TRANS/WP.29/GRSP/2005/9/Corr.1  
16 September 2005

World Forum for Harmonization of Vehicle Regulations (WP.29)

PROPOSAL FOR DRAFT AMENDMENTS TO REGULATION No. 11  
(Door latches and door retention components)

Corrigendum

Figure 3-4 - Door Static Load Test Directions."

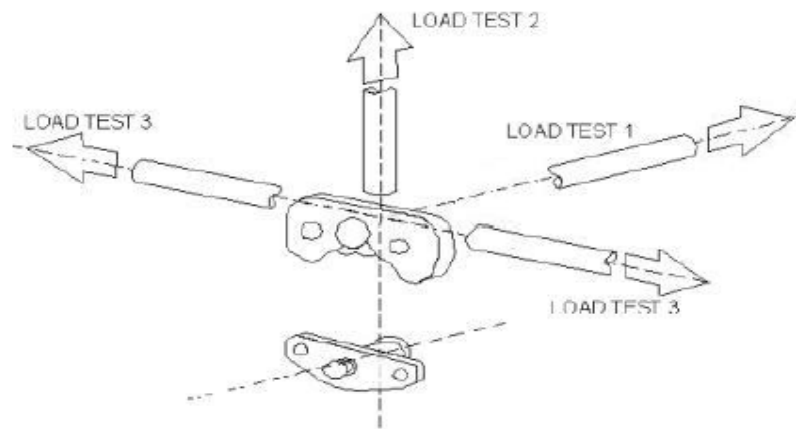
Annex 3, replace figure 3-4 by the following figure:
